**Model  
Administrative Change Notice**

1. Document Number:	MDL-NBS-HS-000006	2. Revision:	03/ND01	3. ACN:	01
4. Title:	UZ Flow Models and Submodels				
5. No. of Pages Attached	86 91	87	87-7-08

4. Title: UZ Flow Models and Submodels

Figure 6.1-2. Plan View of Net Infiltration Distributed over the Three-Dimensional Unsaturated Zone TSPA-LA Model Grid for the Present-Day 10th Percentile Infiltration Scenario

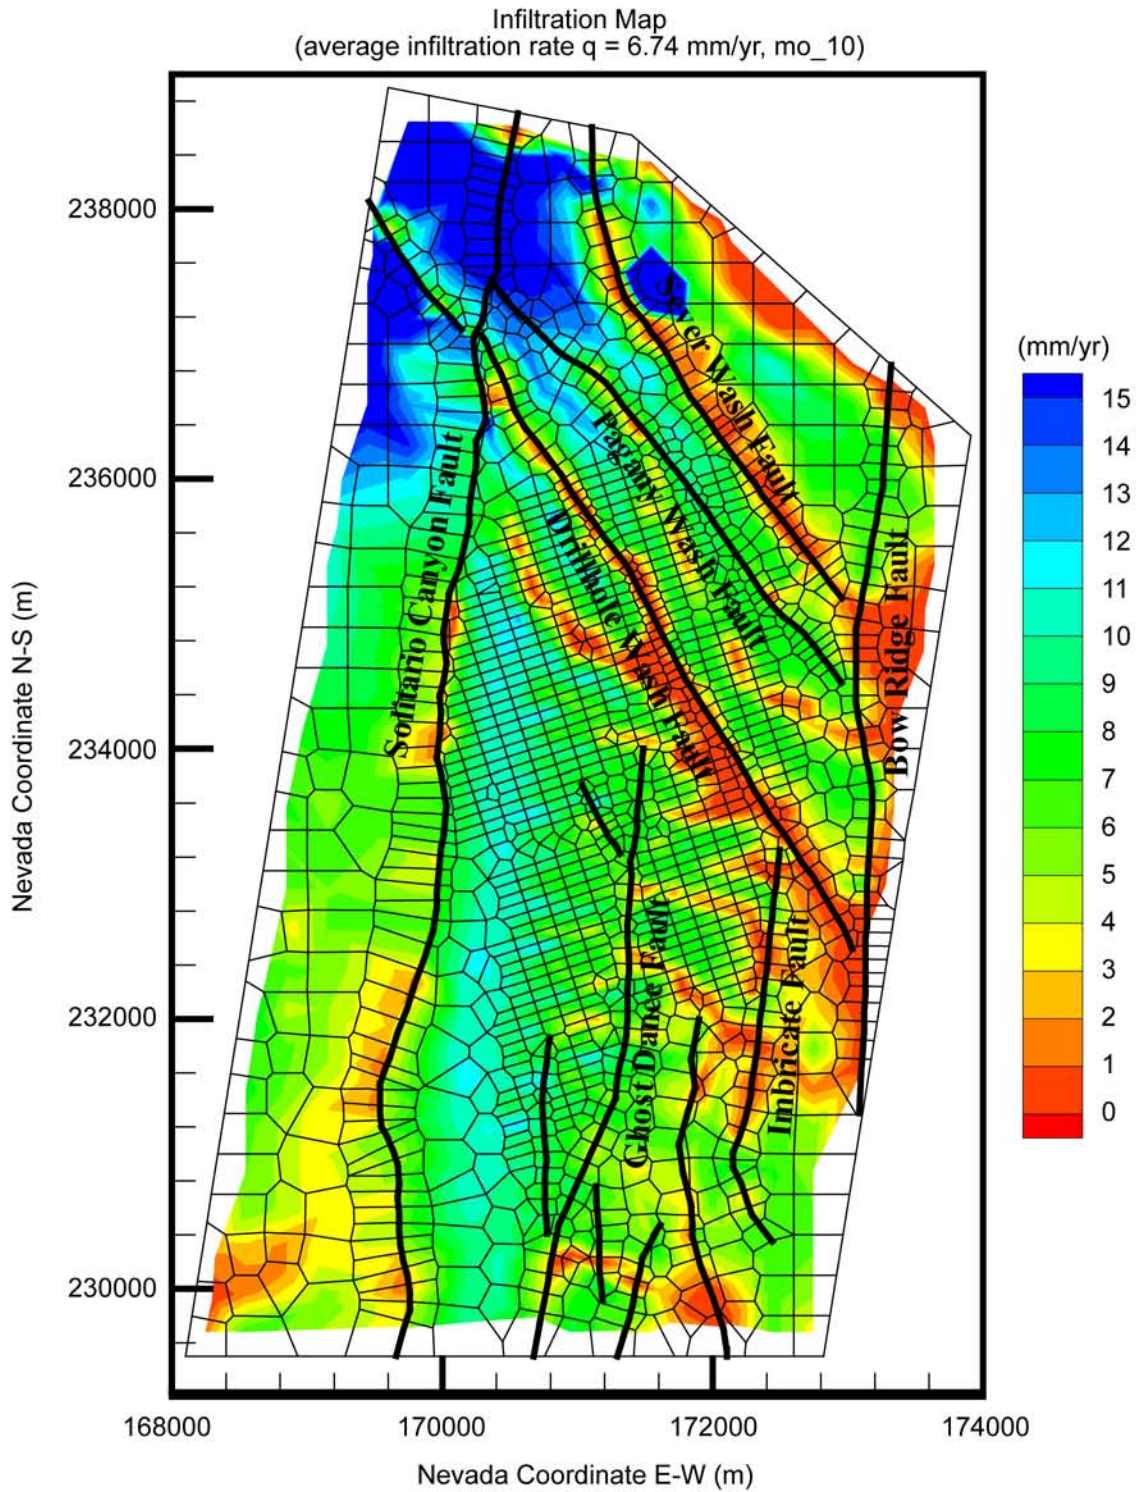
- 6-15 Figure 6.1-2: Replaced figure to correct misspelling of “infiltration” in figure heading.
- 6-16 Figure 6.1-3: Replaced figure to correct misspelling of “infiltration” in figure heading.

Figure 6.1-5. Plan View of Net Infiltration Distributed over the Three-Dimensional Unsaturated Zone TSPA-LA Model Grid for the Post-10,000-yr Period Climate, 10th Percentile Infiltration Scenario

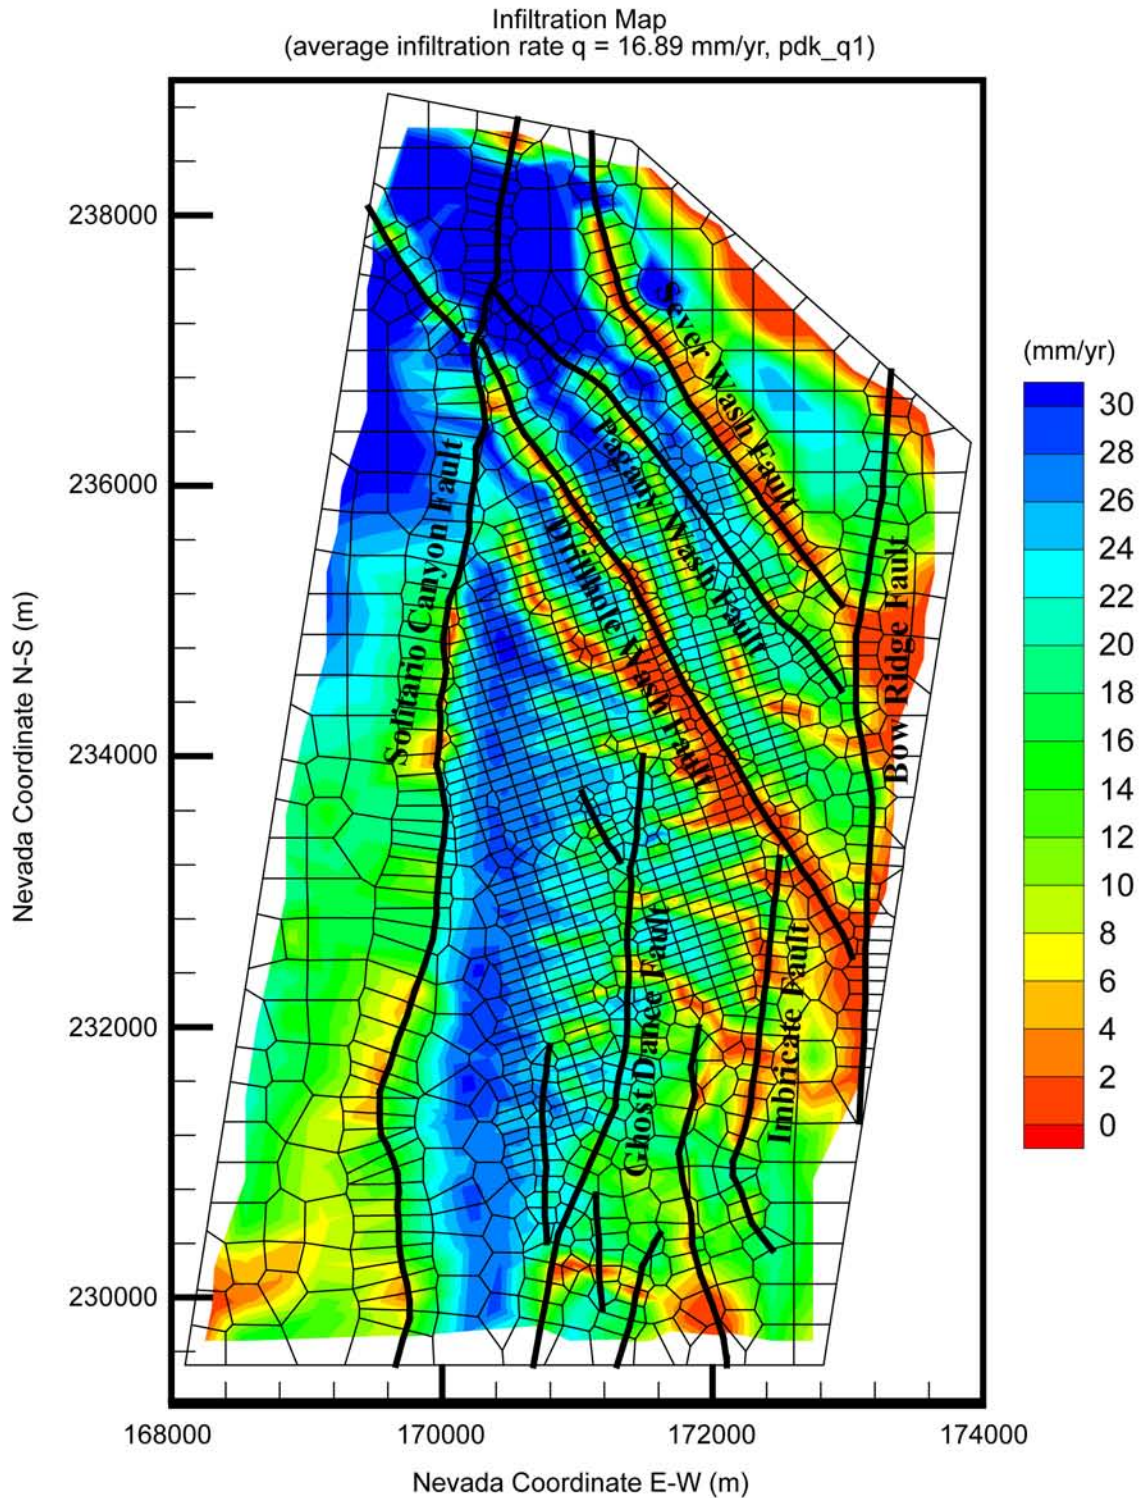
- 6-19 Table 6.1-3: Changed “percentiles” to “percentile” in 4th row under “Scenario” column.
- 6-20 Figure 6.1-5: Replaced figure to correct misspelling of “infiltration” in figure heading.

Figure 6.4-2. Comparison of Simulated (solid line) and Observed (solid dots) Gas Pressures at Borehole SD-12 during the First 30-Day Period

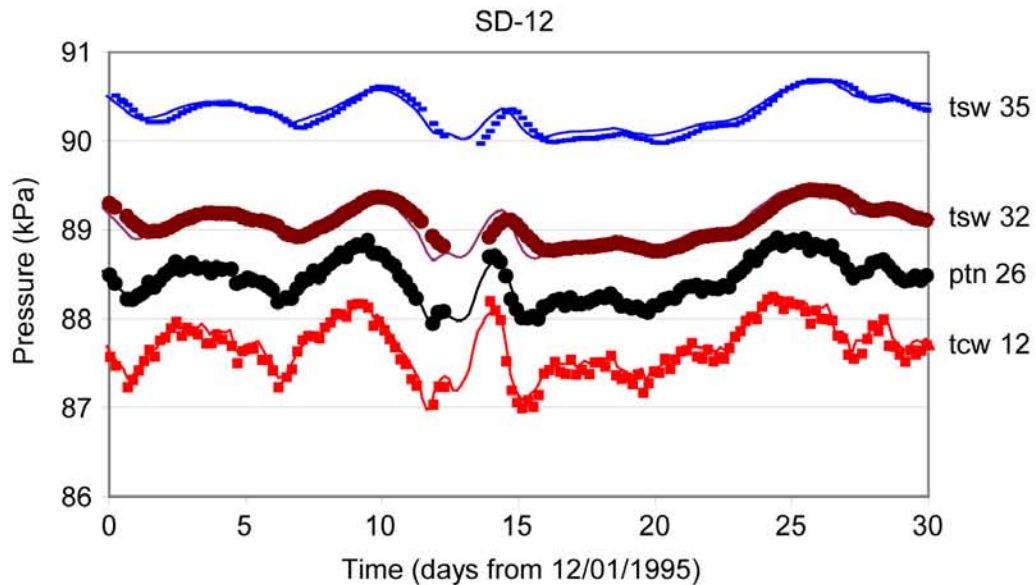
- 6-60 Figure 6.4-2: Replaced figure to correct the UZ model grid unit labeling on the curves (e.g., “tcw 12”, “tsw 35”, etc.) and to change the units on the y-axis label from “KPa” to “kPa”.  
Figure 6.4-2, NOTE: Added “The hydrogeologic units shown on the figure (e.g., tcw12) are determined from a comparison of the borehole location and measurement depth with the spatial data for the hydrogeologic units available from the UZ model grid.”

Figure 6.4-3. Comparison of Simulated (solid line) and Observed (solid dots) Gas Pressures at Borehole UZ-7a during the First 30-day Period

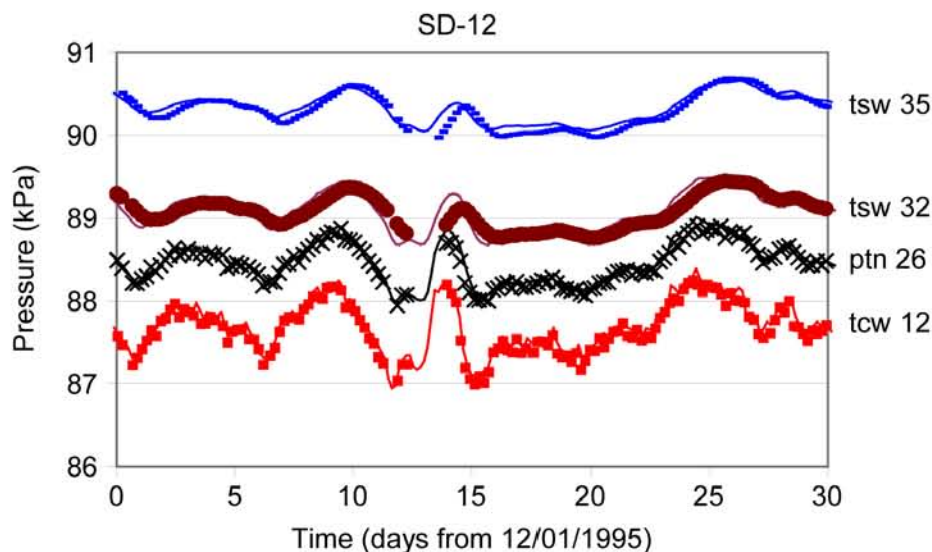
- 6-62 Figure 6.4-3: Replaced figure to correct the UZ model grid unit labeling on the curves (e.g., “tcw 12”, “tsw 32”, etc.) and to change the units on the y-axis label from “KPa” to “kPa”. Also changed “UZ-71” to “UZ-7a” in figure caption.  
Figure 6.4-3, NOTE: Added “The hydrogeologic units shown on the figure (e.g., tcw12) are determined from a comparison of the borehole location and measurement depth with the spatial data for the hydrogeologic units available from the UZ model grid.”

Figure 6.6-2. Simulated Percolation Fluxes at the Repository Horizon under the Monsoon, 10th Percentile Infiltration Scenario

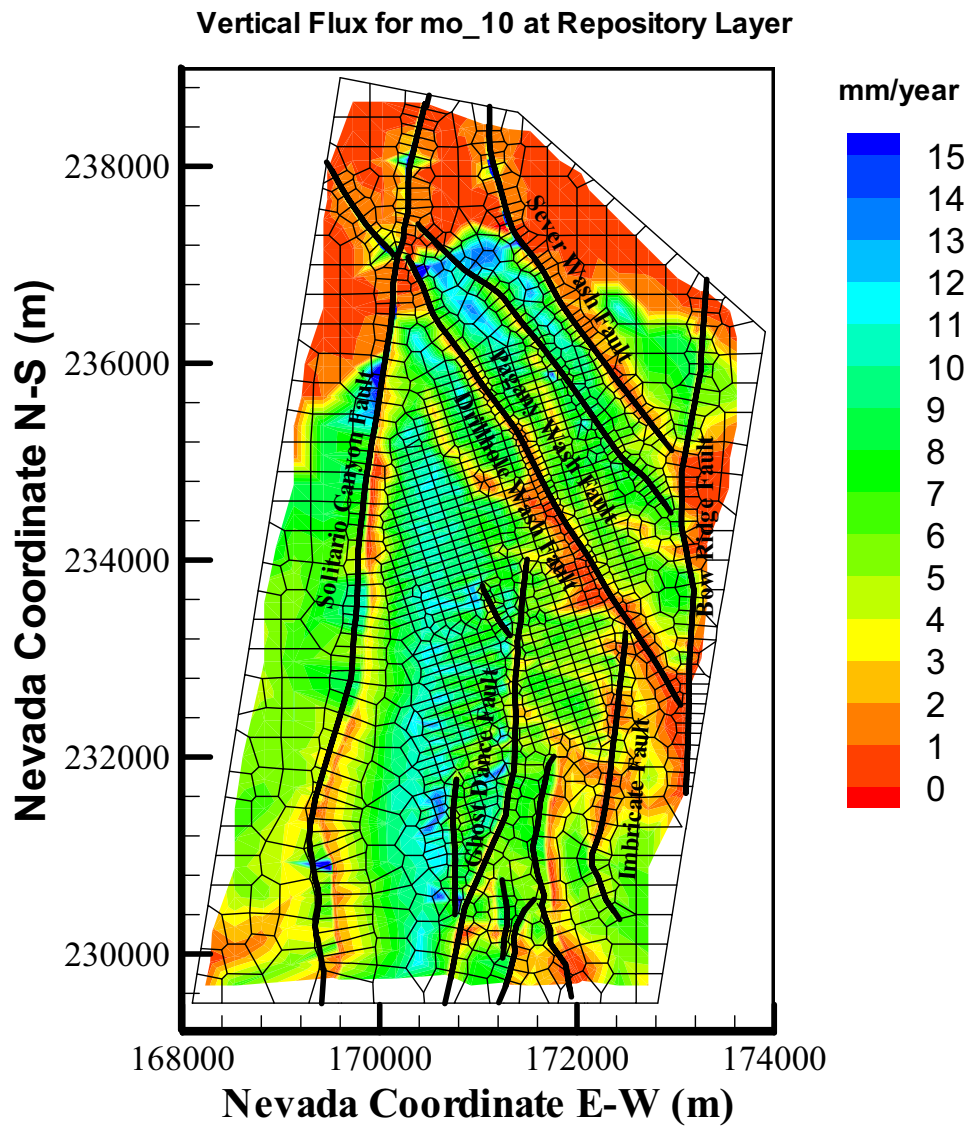
- 6-83 Figure 6.6-2: Removed superscripting from “th” in “10th” in caption. Figure caption now reads:  
“Simulated Percolation Fluxes at the Repository Horizon under the Monsoon, 10th Percentile Infiltration Scenario”.

Figure 6.8-2. Posterior Weighting Factors for Infiltration Map

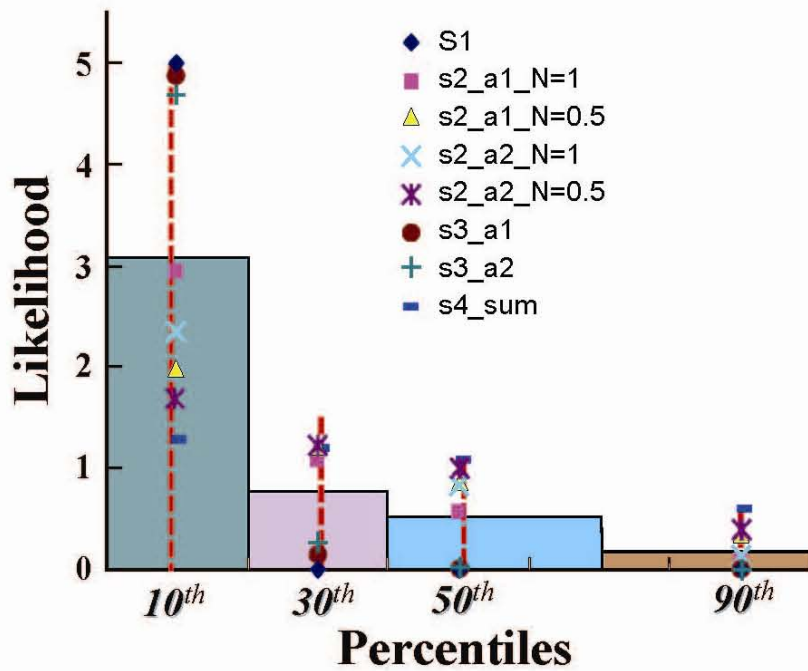
- 6-118      Figure 6.8-2: Replaced figure to make the plotting symbols visible in the shaded portions of the figure.  
Figure 6.8-2, NOTE: Placed figure note on separate line from DTN listing.

Figure 7.4-1. Comparison of Predicted (solid line) and Observed (solid dots) Gas Pressures at Borehole UZ-7a During the Second 30-day Period for the 10th Percentile Infiltration Scenario

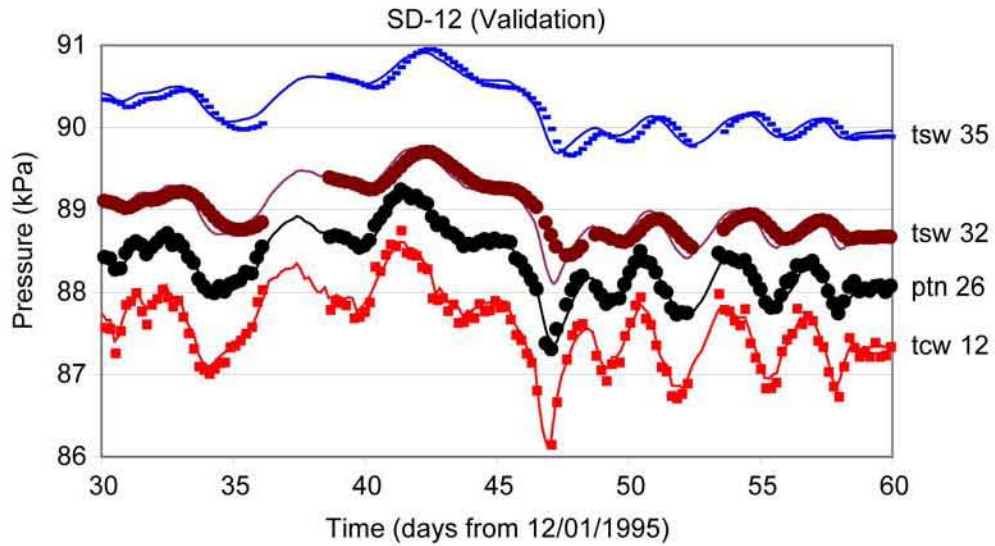
- 7-4      Second paragraph, last sentence: Replaced “model is” with “model’s”.
- 7-9      Heading for Section 7.4.1: Added a “th” after “10”. Heading now reads: “Validation of the UZ Model for the Scenario of the 10th-Percentile Infiltration Map”.  
Figure 7.4-1: Replaced figure to correct the UZ model grid unit labeling on the curves (e.g., “tcw 12”, “tsw 32”, etc.) and to change the units on the y-axis label from “KPa” to “kPa”.  
Figure 7.4-1, NOTE: Added “The hydrogeologic units shown on the figure (e.g., tcw12) are determined from a comparison of the borehole location and measurement depth with the spatial data for the hydrogeologic units available from the UZ model grid.”

Figure 7.4-2. Comparison of Predicted (solid line) and Observed (solid dots) Gas Pressures at Borehole SD-12 During the Second 30-day Period for the 10th Percentile Infiltration Scenario

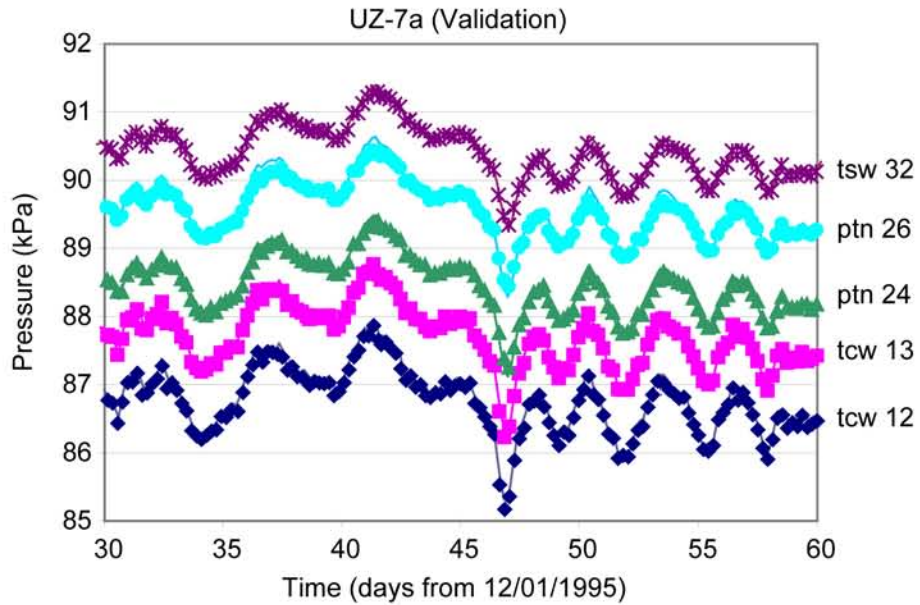
- 7-10      Figure 7.4-2: Replaced figure to correct the UZ model grid unit labeling on the curves (e.g., “tcw 12”, “tsw 35”, etc.) and to change the units on the y-axis label from “KPa” to “kPa”.  
Figure 7.4-2, NOTE: Added “The hydrogeologic units shown on the figure (e.g., tcw12) are determined from a comparison of the borehole location and measurement depth with the spatial data for the hydrogeologic units available from the UZ model grid.”

Figure 7.4-3. Comparison of Predicted (solid line) and Observed (solid dots or symbols) Gas Pressures at Borehole UZ-7a During the Second 30-day Period for the 30th Percentile Infiltration Scenario

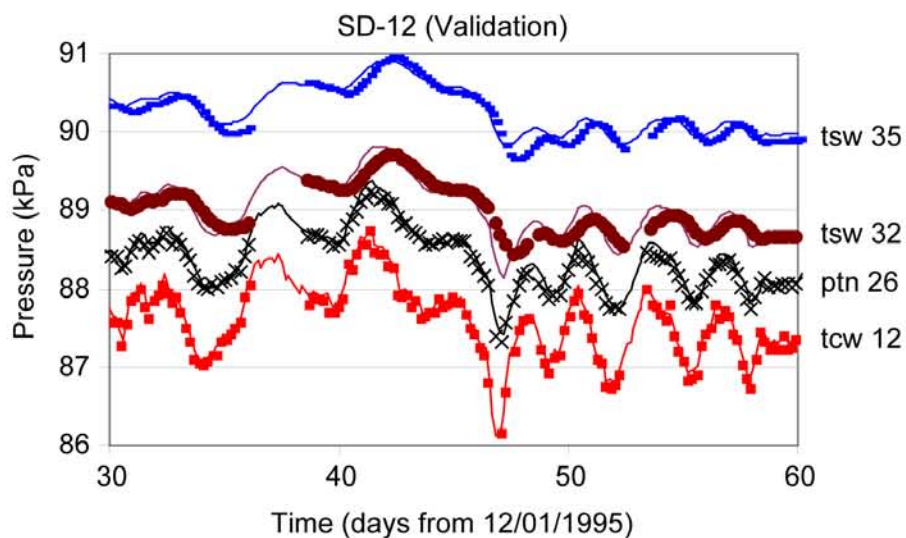
- 7-11      Figure 7.4-3: Replaced figure to correct the UZ model grid unit labeling on the curves (e.g., “tcw 12”, “tsw 32”, etc.) and to change the units on the y-axis label from “KPa” to “kPa”.  
Figure 7.4-3, NOTE: Added “The hydrogeologic units shown on the figure (e.g., tcw12) are determined from a comparison of the borehole location and measurement depth with the spatial data for the hydrogeologic units available from the UZ model grid.”

Figure 7.5-1. Simulated Solute Travel Time of the Matrix Pore Water with Three-dimensional Simulation for Borehole UZ-1 Compared to the Measured <sup>14</sup>C Age

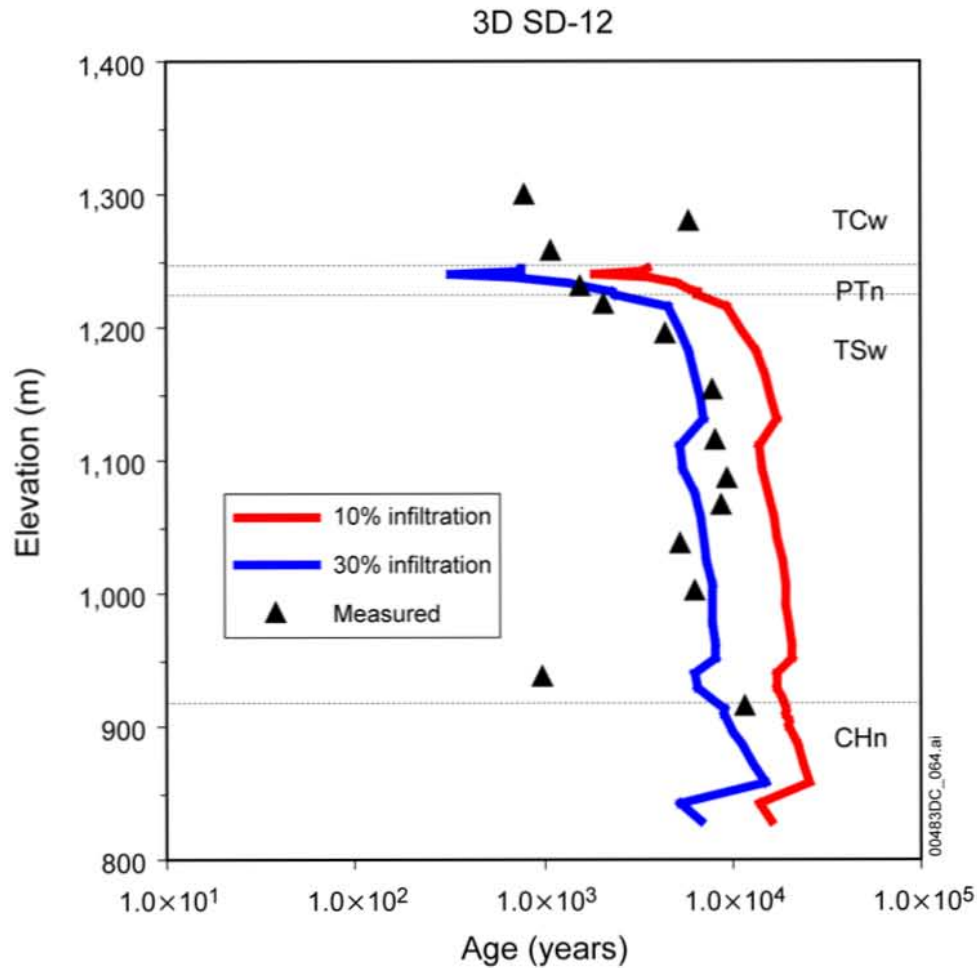
- 7-16      Figure 7.5-1: Changed “UZ-1 Borehole” to “Borehole UZ-1” in figure caption.
- 7-17      Figure 7.5-2: Changed “SD-12 Borehole” to “Borehole SD-12” in figure caption.

Figure 7.5-3. Simulated Solute Travel Time of the Matrix Pore Water with One-dimensional Simulation for Borehole UZ-1 Compared to the Measured  $^{14}\text{C}$  Age

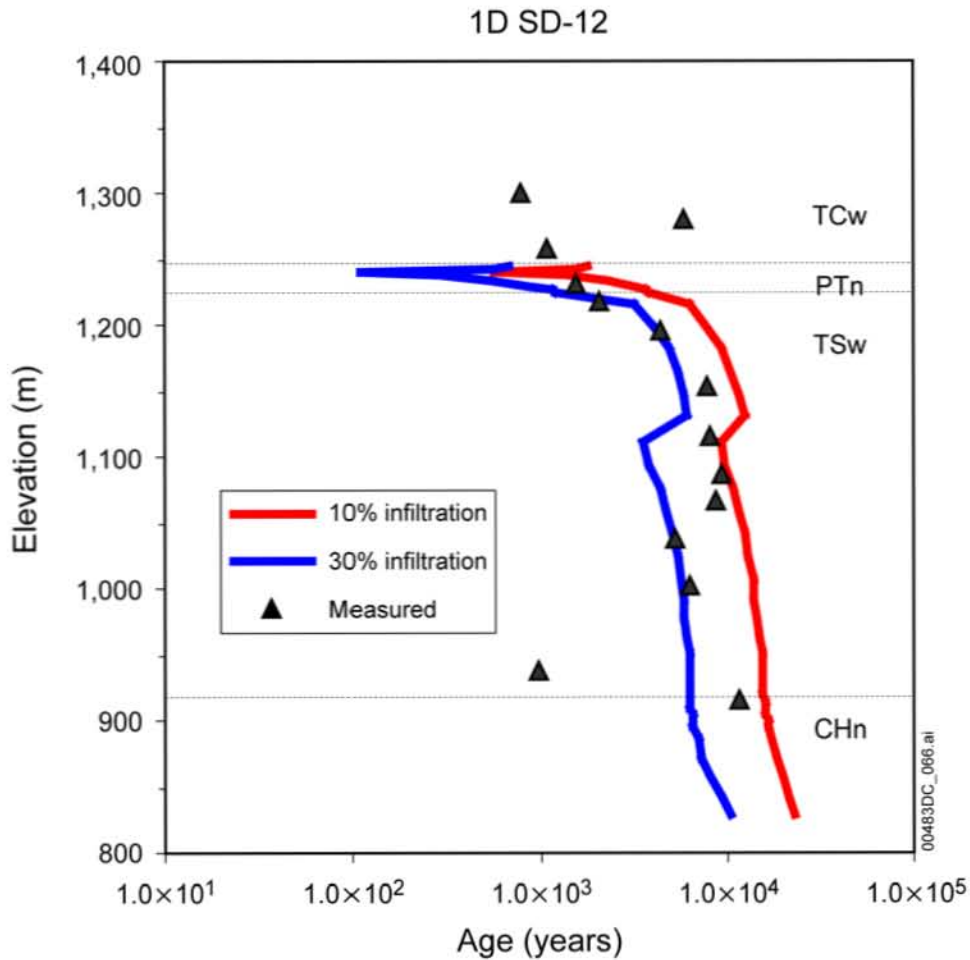
xvii	Listing for Figure 7.5-3: Changed listing to "Simulated Solute Travel Time of the Matrix Pore Water with One-dimensional Simulation for Borehole UZ-1 Compared to the Measured <sup>14</sup> C Age" to reflect corresponding figure caption change (see entry for p. 7-19 below). Listing for Figure 7.5-4: Changed listing to "Simulated Solute Travel Time of the Matrix Pore Water with One-dimensional Simulation for Borehole SD-12 Compared to the Measured <sup>14</sup> C Age" to reflect corresponding figure caption change (see entry for p. 7-20 below).

- 7-18      Second paragraph, 5th line: Inserted “the” before “10th and 30th”.
- 7-19      Figure 7.5-3: Changed “UZ-1 Borehole” to “Borehole UZ-1” in figure caption.
